Project	<b>IEEE 802.16 Broadband Wireless Access Working Group</b> < <a href="http://ieee802.org/16">http://ieee802.org/16</a> >	
Title	<b>Symmetric UL/DL diversity permutations for OFDMA PHY</b>	
Date Submitted	<b>2004-11-17</b>	
Source(s)	Ran Yaniv, Tal Kaitz, Vladimir Yanover, Naftali Chayat	<a href="mailto:ran.yaniv@alvarion.com">ran.yaniv@alvarion.com</a>
	<b>Alvarion Ltd.</b>	<a href="mailto:tal.kaitz@alvarion.com">tal.kaitz@alvarion.com</a>
	Yuval Lomnitz	<a href="mailto:yuval.lomnitz@intel.com">yuval.lomnitz@intel.com</a>
	<b>Intel</b>	
	Dave Pechner, Todd Chauvin, Doug C. Dahlby	<a href="mailto:dpechner@arraycomm.com">dpechner@arraycomm.com</a>
	<b>ArrayComm</b>	<a href="mailto:chauvin@arraycomm.com">chauvin@arraycomm.com</a>
		<a href="mailto:dahlby@arraycomm.com">dahlby@arraycomm.com</a>
	Bin-Chul Ihm, Yongseok Jin, Jinyoung Chun, Kyuhyuk Chung	<a href="mailto:bcihm@lge.com">bcihm@lge.com</a>

# Symmetric UL/DL diversity permutations for OFDMA PHY

Figure 219 – Illustration of OFDMA frame with multiple zones

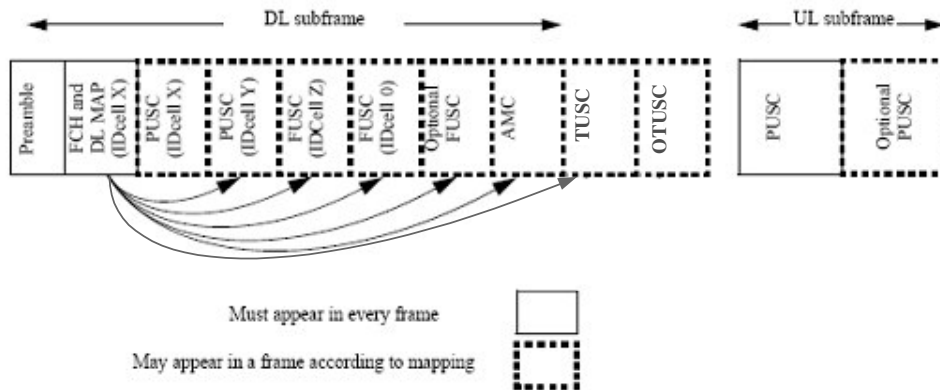
The OFDMA frame may include multiple zones (such as PUSC, FUSC, PUSC with all subchannels, optional FUSC, AMC, ~~and~~ optional FUSC with all subchannels, TUSC, and optional TUSC), the transition between zones is indicated in the DL-Map by the Zone\_switch IE (see 8.4.5.3.4). No DL-MAP or UL-MAP allocations can span over multiple zones. Figure 219 depict OFDMA frame with multiple zones.

### 3. [Replace figure 219 on page 503 with the following figure]

**Figure 252e – Mapping of data subcarriers in STC with matrix indicator A.**

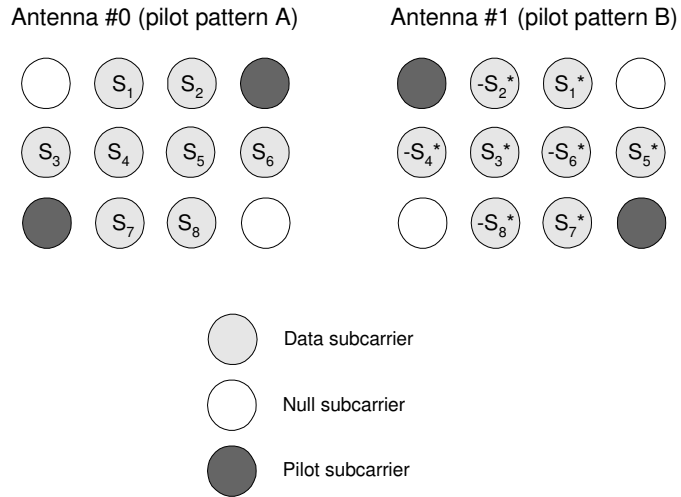
Two STC modes for 2-antenna configuration are defined for the TUSC structure. The first mode, identified by STC matrix indicator 'A', provides STC rate of 1 by encoding subcarrier pairs within each tile. In this mode, the tiles shall be allocated to subchannels and the data subcarriers enumerated as defined in 8.4.6.1.2.4. The pilots in each tile shall be split between the two antennas and the data subcarriers shall be encoded in pairs after constellation mapping, as depicted in figure 252e. The data subcarriers transmitted from Antenna #0 follow the original mapping defined in 8.4.6.1.2.4.
